COMMITTEE OF EXPERTS ON THE TRANSPORT OF DANGEROUS GOODS AND ON THE GLOBALLY HARMONIZED SYSTEM OF CLASSIFICATION AND LABELLING OF CHEMICALS

Sub-Committee of Experts on the Transport of Dangerous Goods

EXPLOSIVES, SELF-REACTIVE SUBSTANCES AND ORGANIC PEROXIDES

Ammonium nitrate emulsions, suspensions and gels

Figure 10.4 Procedure for ammonium nitrate emulsion, suspension and gel, intermediate for blasting explosives

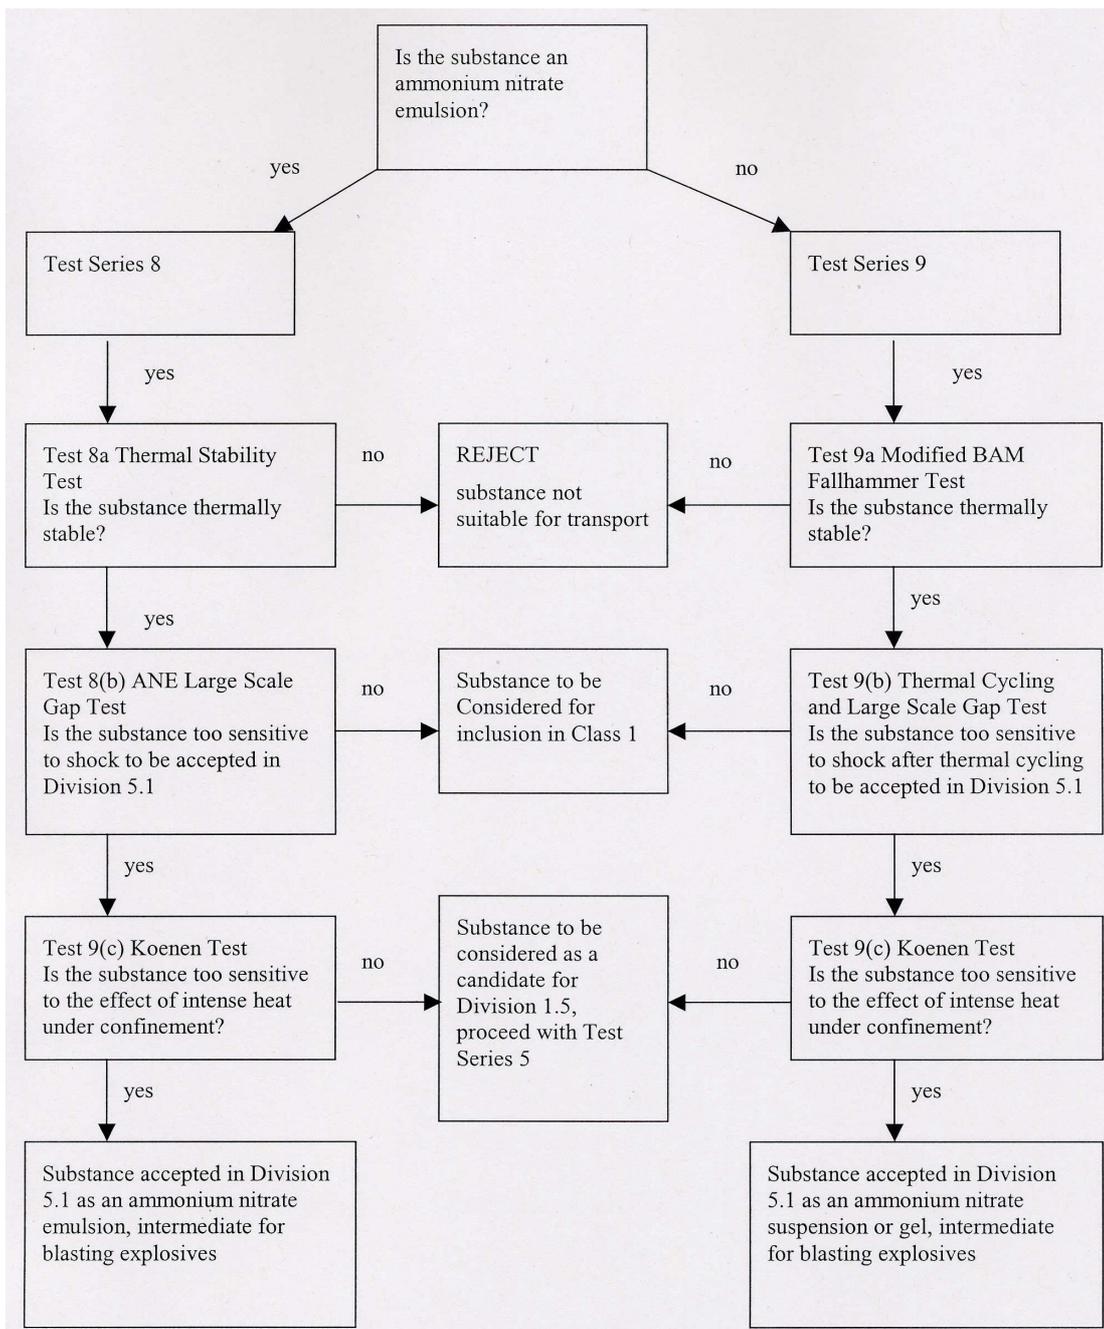
13. The United Kingdom also proposes that Box 2a is amended to remove "ANE" at the end of the text and a modified Box 19 in Figure 10.2 be changed to include Test Series 8 and a new Test Series 9 which will be used to classify ammonium nitrate suspensions and gels into Class 5.1. The flow chart for this proposed test is described in Annex 1 of this document

14. The proposed Test Series 9 should include a test which subjects the ammonium nitrate suspension or gel to five thermal cycles +/-25°C of the transport temperature followed by an impact/friction test. The method described in UN/SCETDG/24/INF.54 could be used as the Proposed Test 9(a).

16. The proposed Test 9(b) should subject the ammonium nitrate suspension or gel to five thermal cycles +/-25°C of the transport temperature followed by a detonation test such as the ANE gap test.

17. The proposed Test 9(c) should be the Keonen Test using the same procedure as Test 8(c). The procedures for these Tests 9(a), (b) and (c) are described in Annex 1.

Is the substance a candidate for ammonium nitrate emulsion, suspension or gel, intermediate for blasting explosive?

Test Series 8 & 9
(go to Figure 10.4)
